Development Permit Panel

Wednesday, December 14, 2016
3:30 p.m.

1. **Development Permit 15-696896**
(REDMS No. 5217904)

PROPERTY LOCATION: 7120 No. 3 Road

5 PERMEABLE PAVERS WITH CONCRETE BAND
LP2 N.T.S.

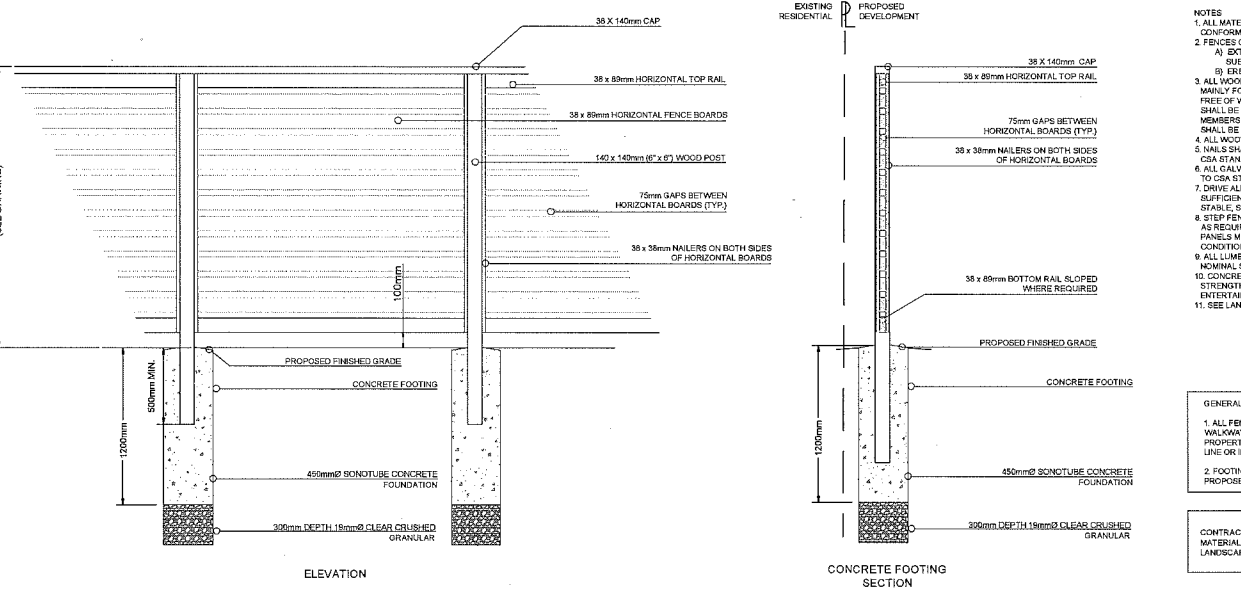
- agree with comment to reconsider stamped asphalt paving on the driveway; consider introducing concrete unit pavers;

Permeable pavers have been added for the parking stall areas in the front parking area complete with concrete banding as shown on the site plan. As noted on the detail on L2, two colours of pavers are proposed – one for the field and one to delineate the parking stall lines. The balance of the front parking area is a truck route so we have retained the heavy duty asphalt paving. In addition, the loading area has been changed to stamped concrete and will match the raised pedestrian connection.
